**THE RIVER OAKS**  
PENTHOUSE 3  
3433 WESTHEIMER ROAD, HOUSTON, TEXAS 77027

DRAWING NUMBER  
**A143**  
ENLARGED PLAN  
PENTHOUSE 3  
LEVEL 18

**FLOOR PLAN - PENTHOUSE 3 - LEVEL 18**  
1/1" = 1/8"

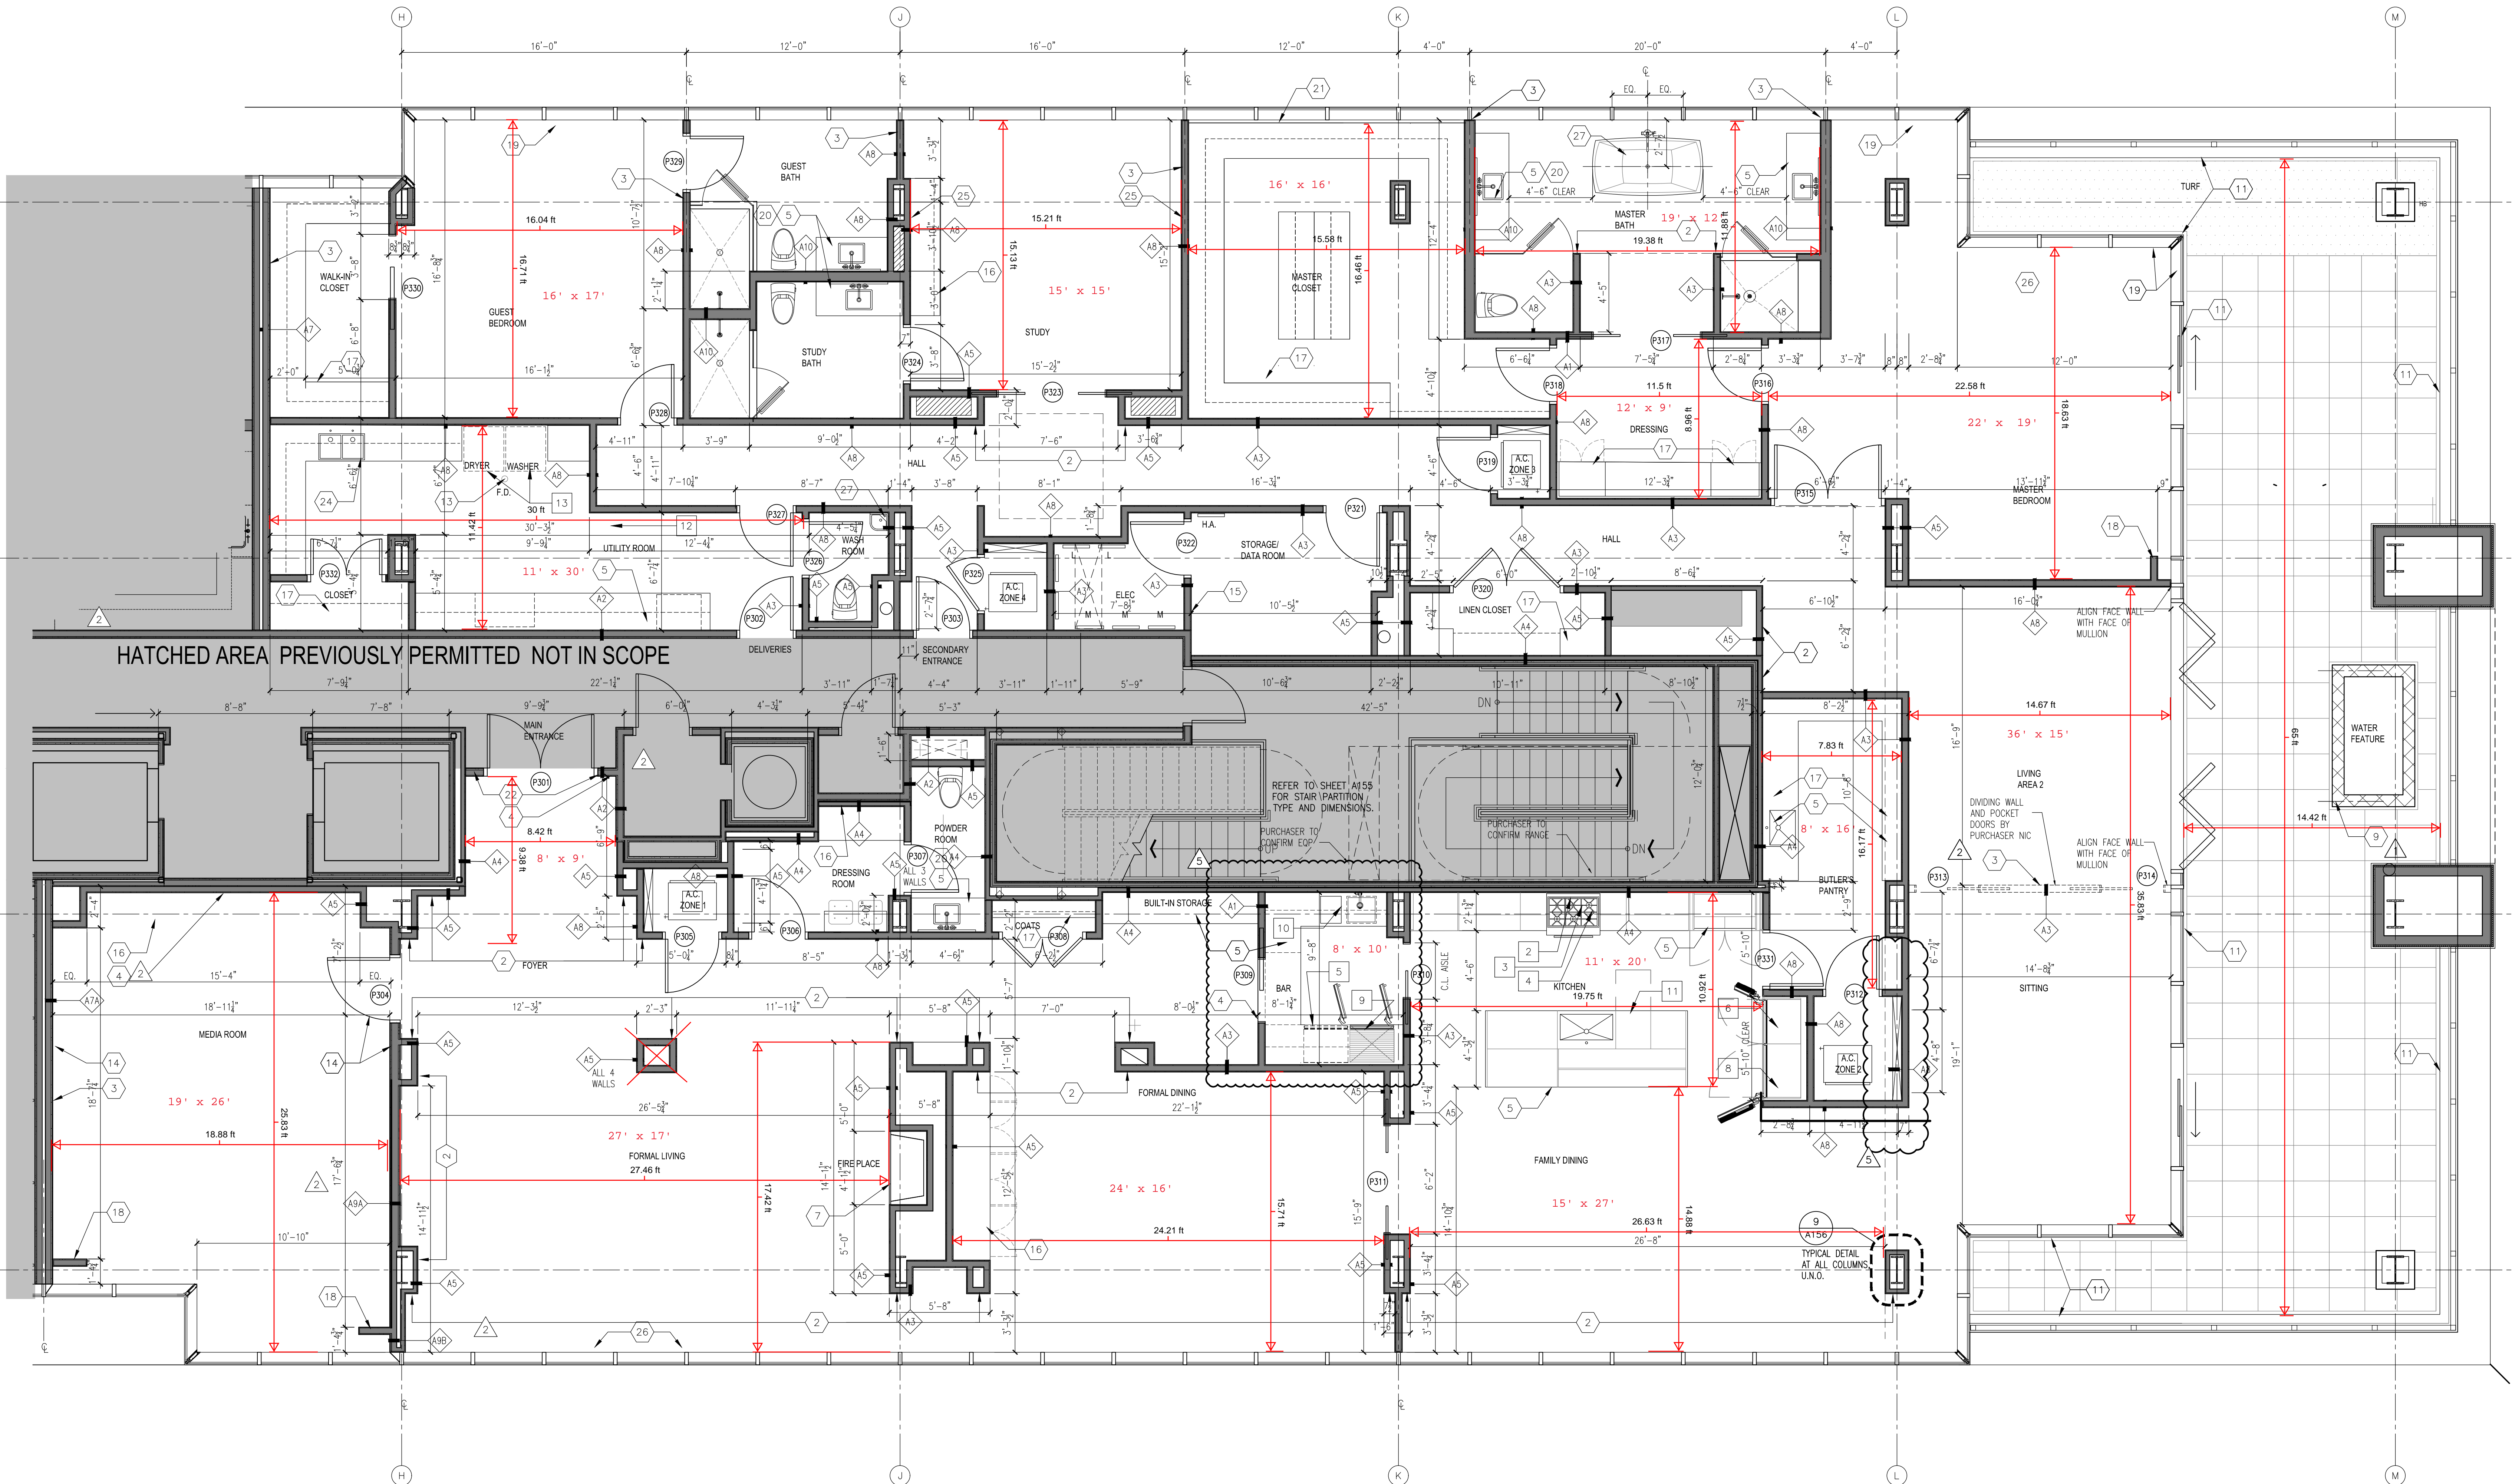
GRAY AREA NOT IN SCOPE
<p>1. SMOKE DETECTION SYSTEMS 902.11.3 Interconnection: where more than one smoke alarm is required to be installed within an individual dwelling unit or sleeping unit in Group R occupancies, the smoke alarms shall be interconnected in such a manner that the activation of one alarm will activate all the alarms in the individual unit.</p> <p>2. 907.2.11.4 POWER SOURCE: required smoke alarms shall receive their primary power from the building wiring where such wiring is served from a commercial source and shall be equipped with a battery backup. Please provide this information on the plans.</p>
<b>LEGEND</b> N.T.S.
